1 Amended North elevation 2016/2016
Pg94 scale 1:100

3 Approved North elevation 1998
Pg94 scale 1:100

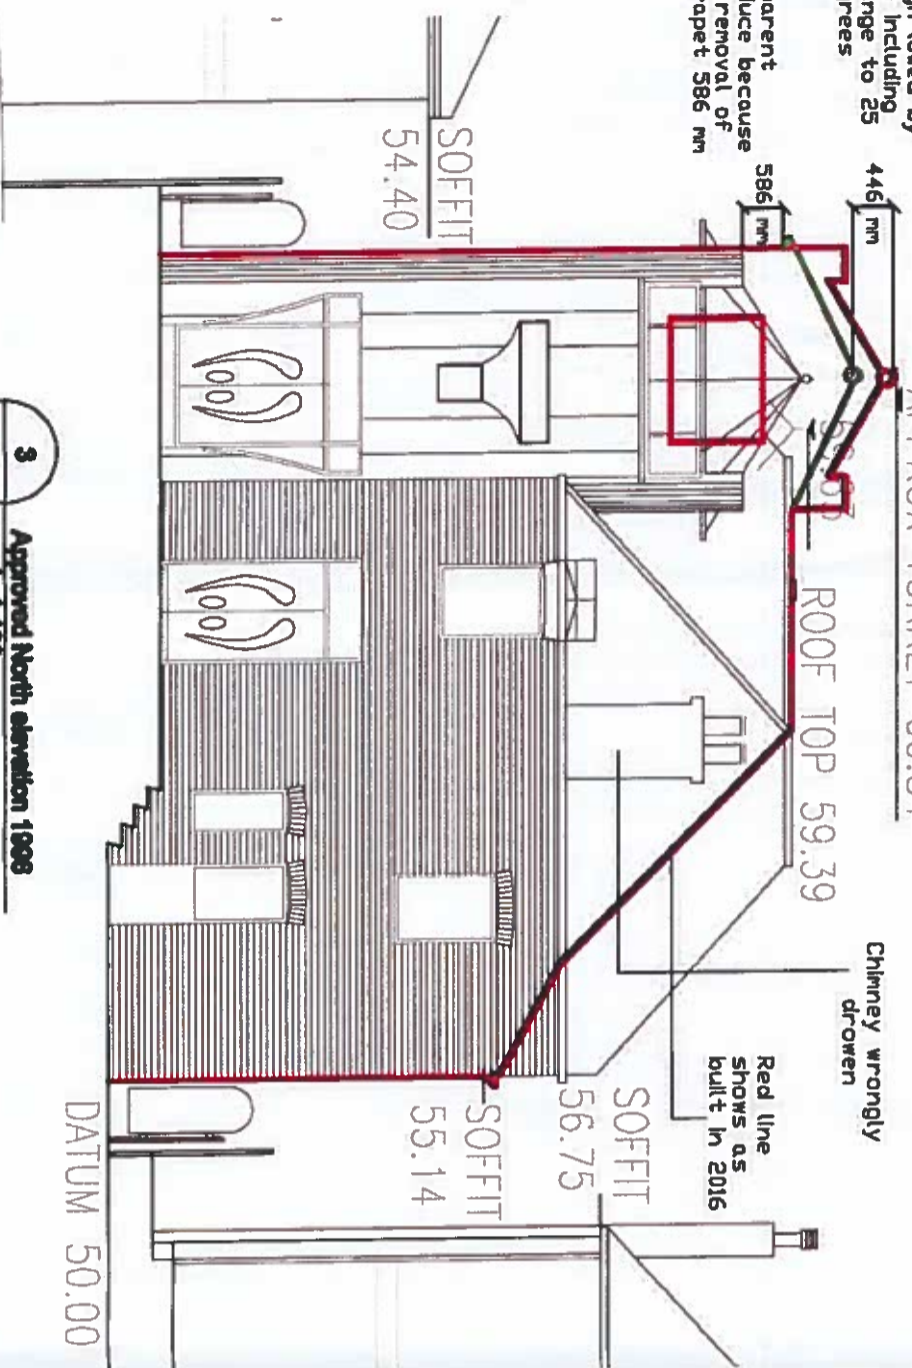
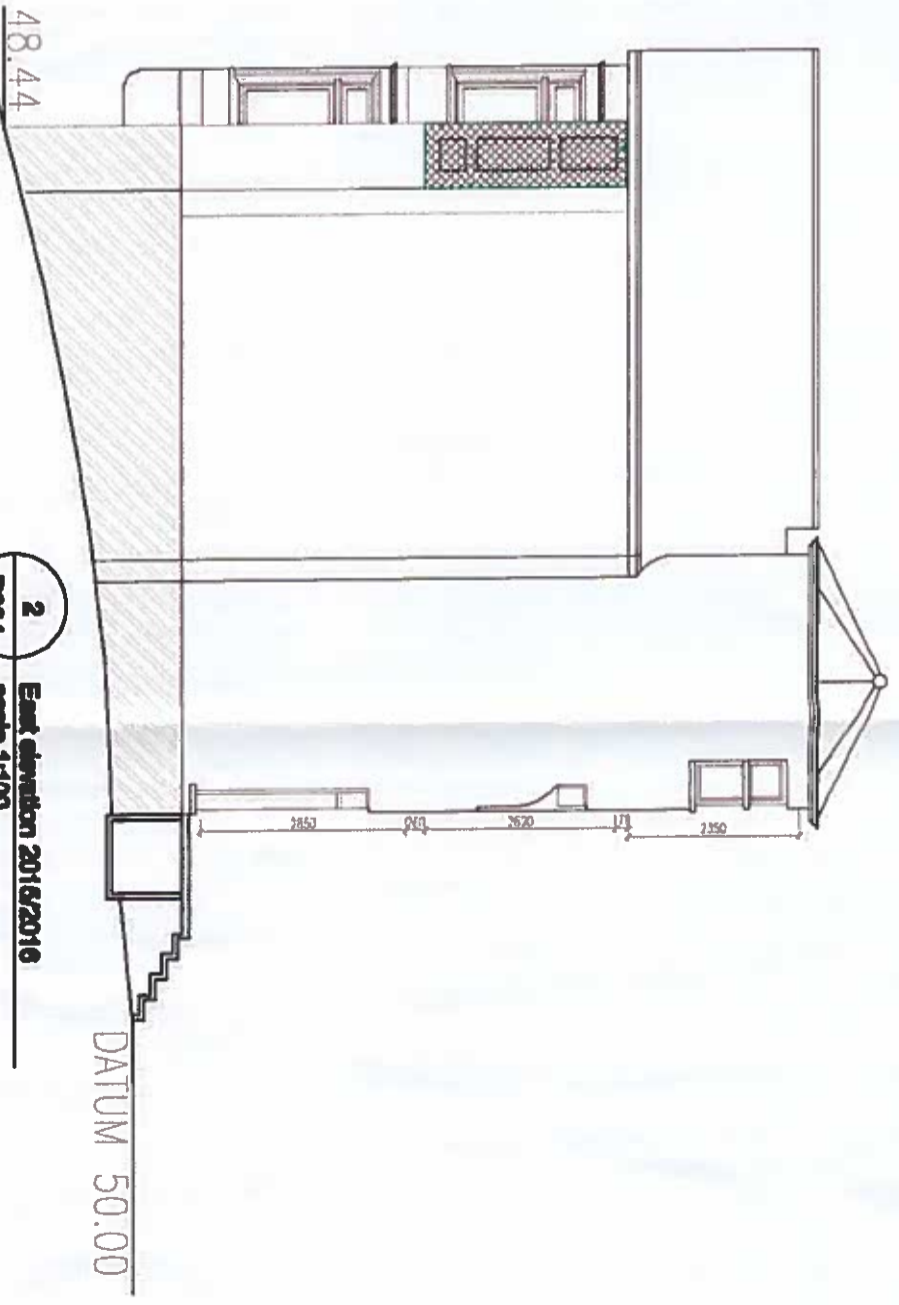
Height lowered by 446 mm including change to 25 degrees

Apparent reduce because of removal of parapet 586 mm
